OUTPUT OF THE CABLE REVIEW

E. Todesco and the QXF team
CERN, Geneva Switzerland

I_c vs RRR for 132/169 RRP strand [A. Ghosh]

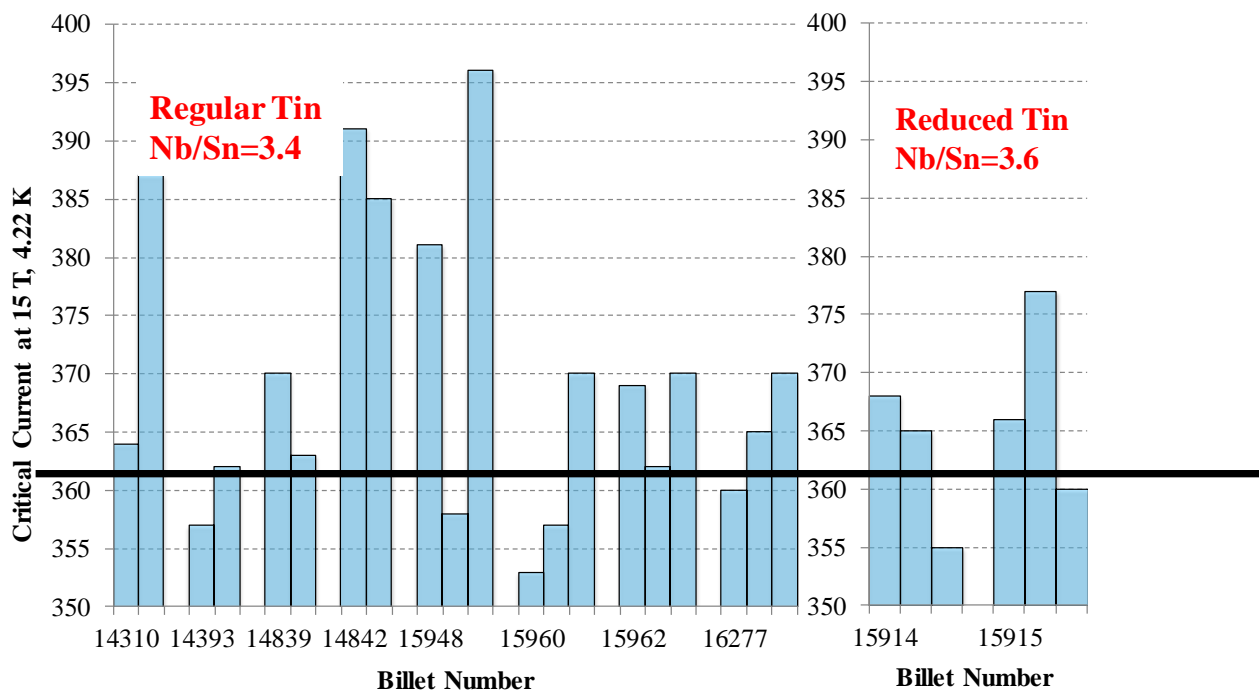
- First major point: the critical current is not there
 - Specifications are not met – further optimization should be done
 - We are >5% lower, I guess (340 A looks comfortable)

I_c for 132/169 RRP strand [B. Bordini]

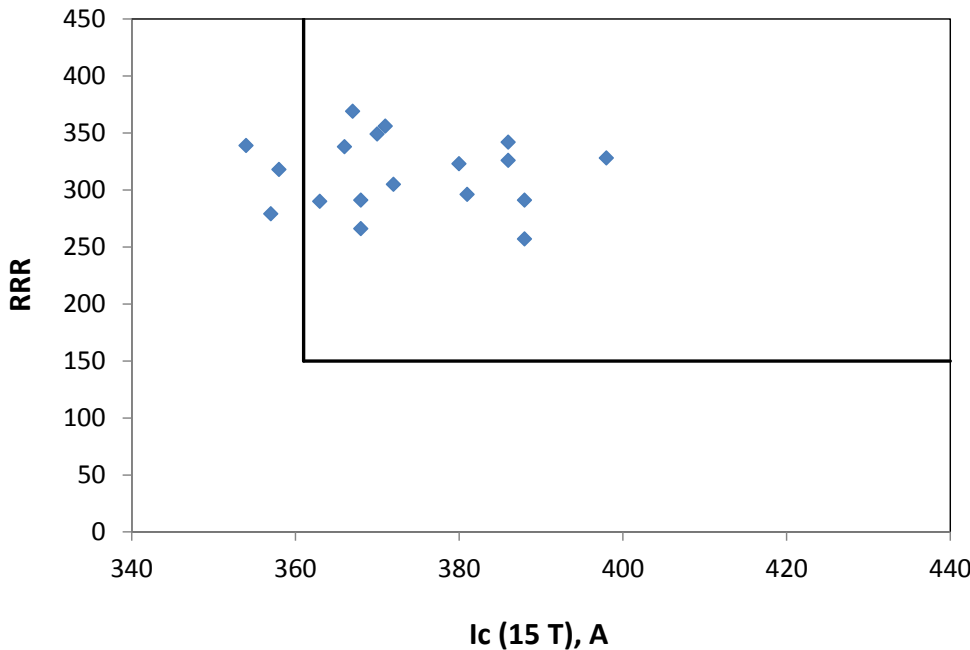
- First major point: the critical current is not there
 - Specifications are not met – further optimization should be done
 - We are >5% lower, I guess (340 A looks comfortable)

Change of heat treatment for RRP to increase critical current [B. Bordini]

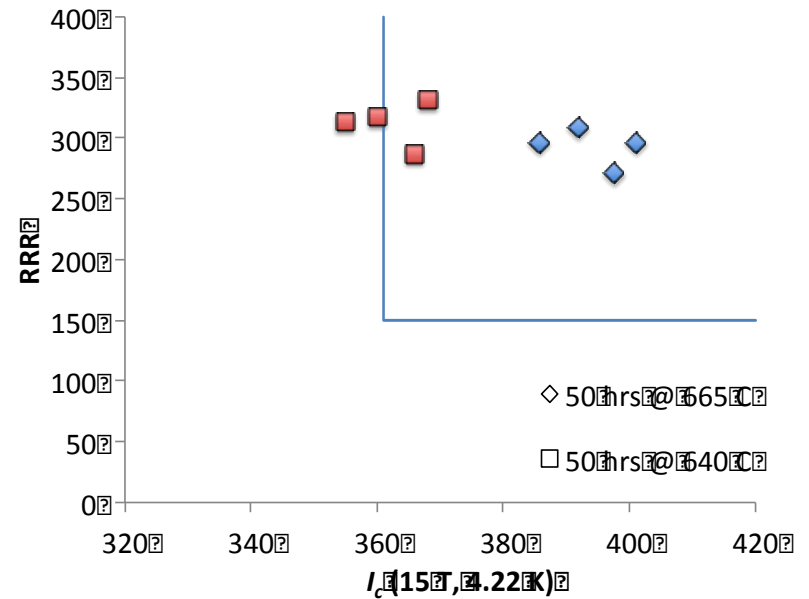
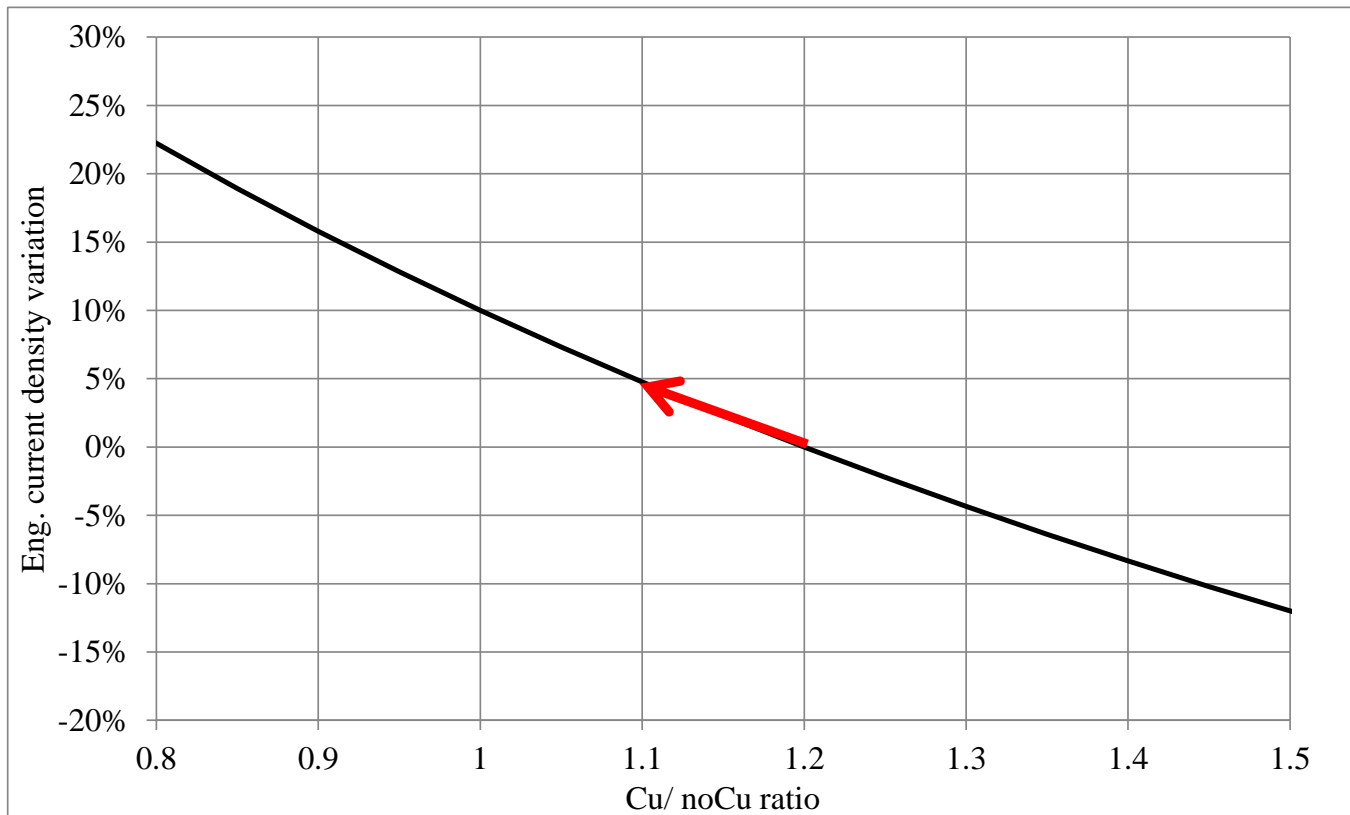
- Possible actions: change heat treatment
 - Best solution, no change of strand layout, no impact on protection ☺

Engineering current density vs Cu/ no Cu ratio

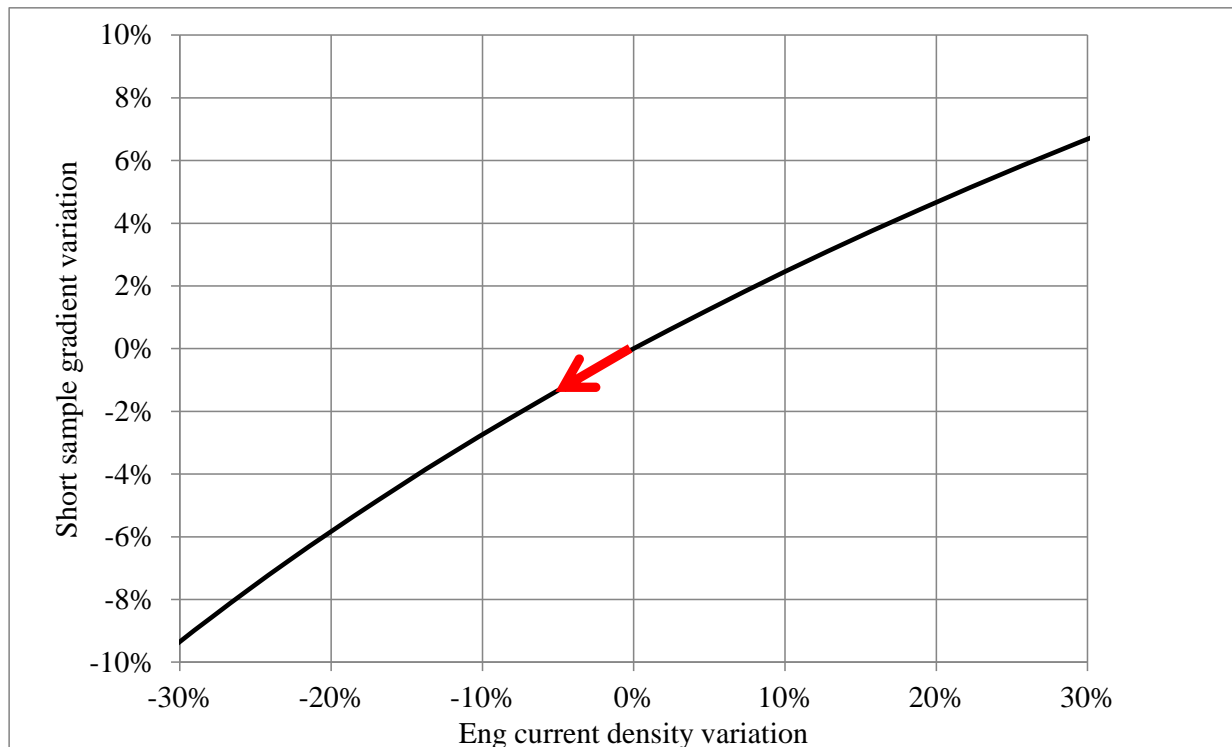
- Possible actions: decrease the copper ratio to 1.1
 - To recover 5% one has to reduce from 1.2 to 1.1 – impact on protection small (6-7 K in hotspot), small change of layout :-/

Engineering current density and short sample gradient vs Cu/ no Cu ratio

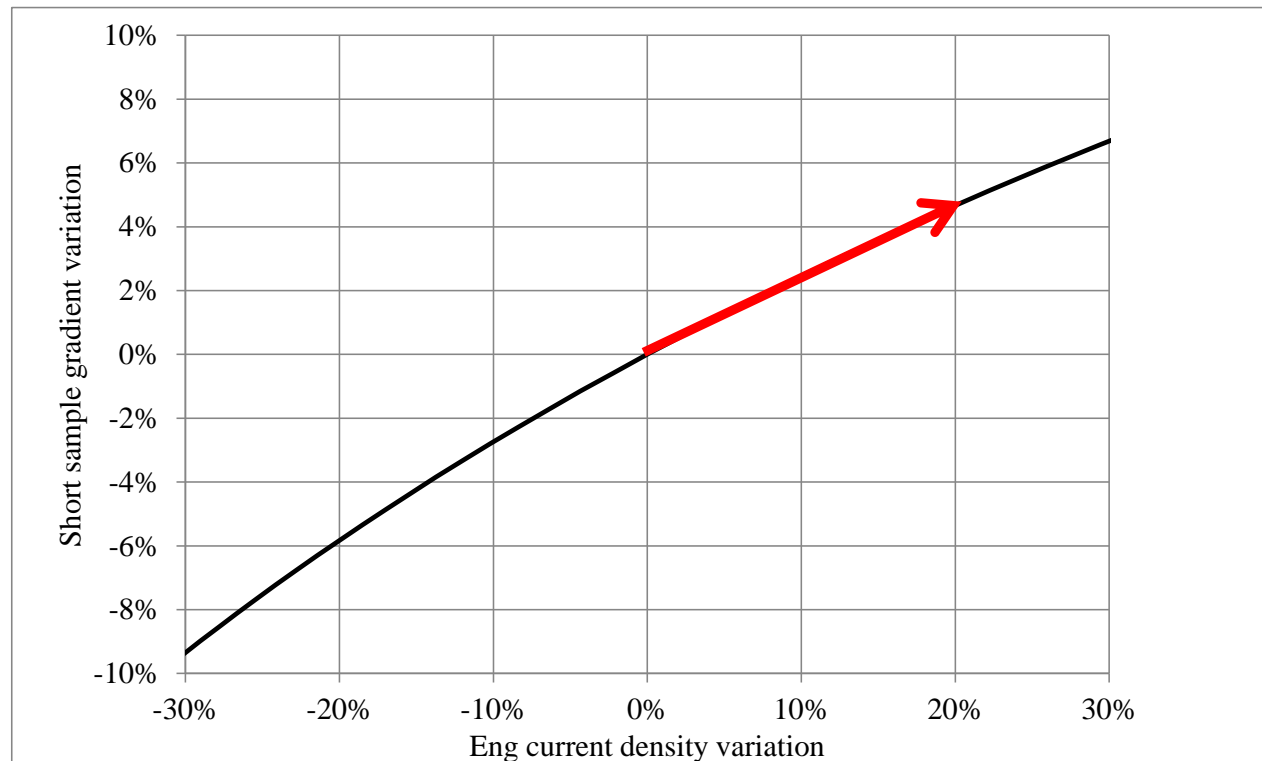
- Others solutions look less viable
 - Example 1: decrease copper – to get 5% more margin you need to lower from 1.2 to 0.8 – non negligible impact on quench protection, which is already tight

short sample gradient vs engineering current density

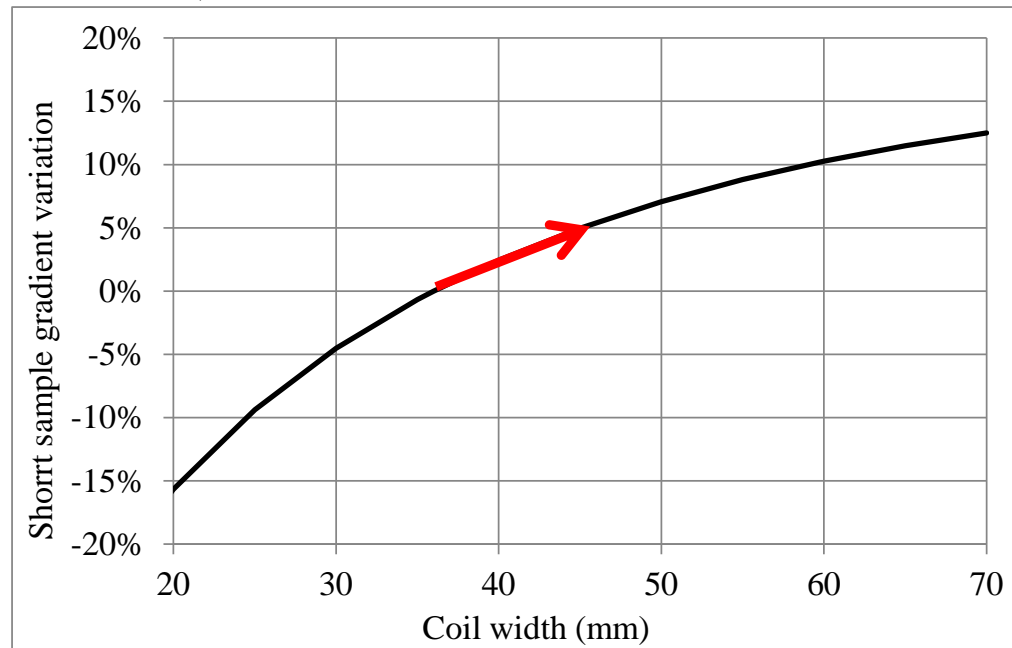
- Others solutions look less viable
 - Example 2: increase current density (already not there) – ~20% more needed to get 5% more margin

Possible fine tuning (0.4° keystone angle cable)

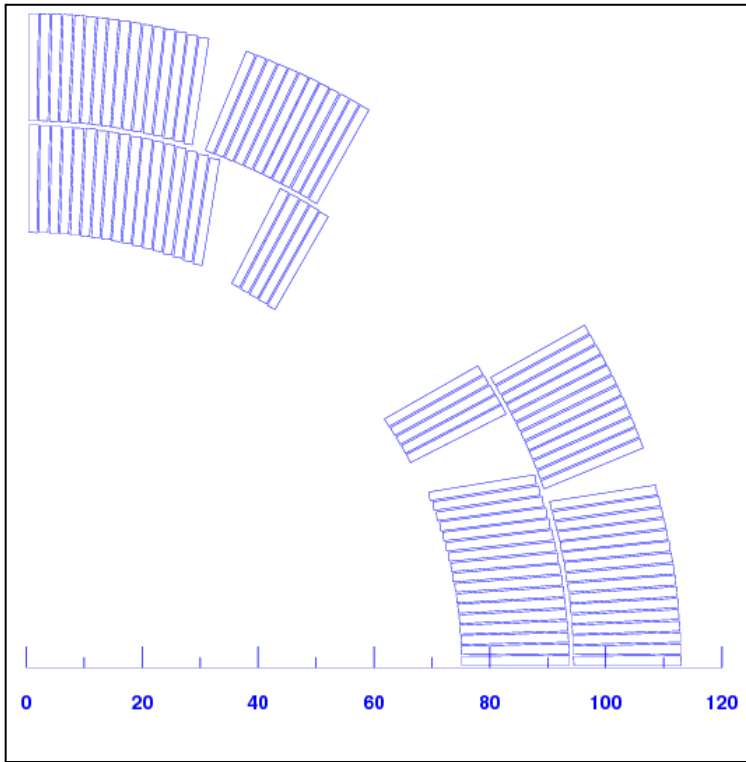
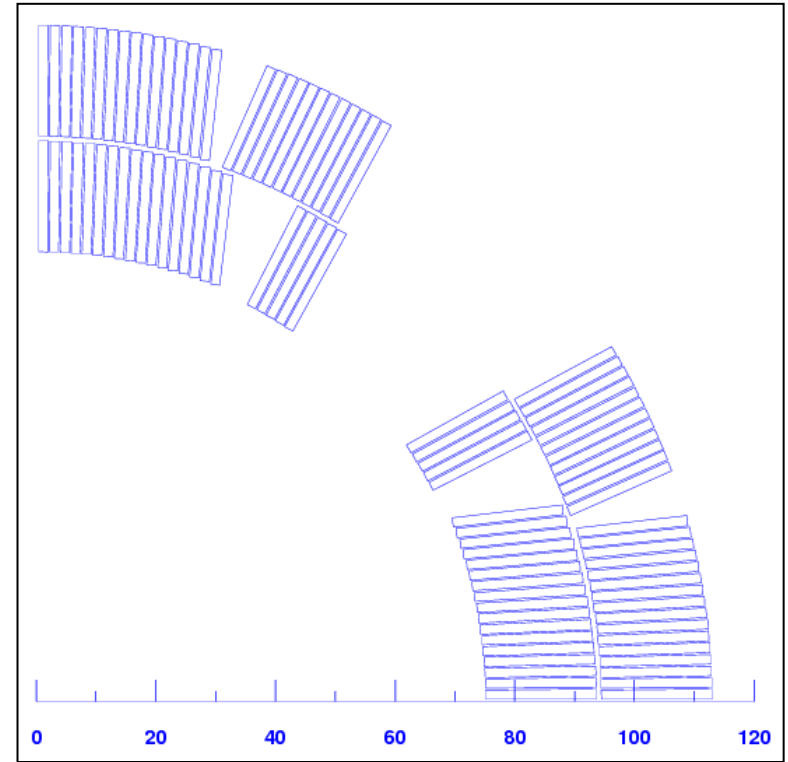
- There is some evidence that a fine tuning of the cable dimension provides less degradation (jc and RRR)
 - Mainly for PIT, could be beneficial for RRP
 - Proposal to reduce keystone angle from 0.65° to 0.4°
 - Minimal impact on cross-section, but a new cross-section
 - Reduction of the risk associated to degradation due to cabling
- Overhead
 - Coils are already being fabricated, but no test done yet
 - If we go now with the fine tuning, we lose one/two model for statistics of reproducibility
 - Or better, we lose the statistic on b_6 , but not on a_3, b_3, a_4, b_4 , which are the most worrying
 - Otherwise we wait for the end of the model, get statistic, and make fine tuning for the production

- I would call this a fine tuning, not a change of cross-section
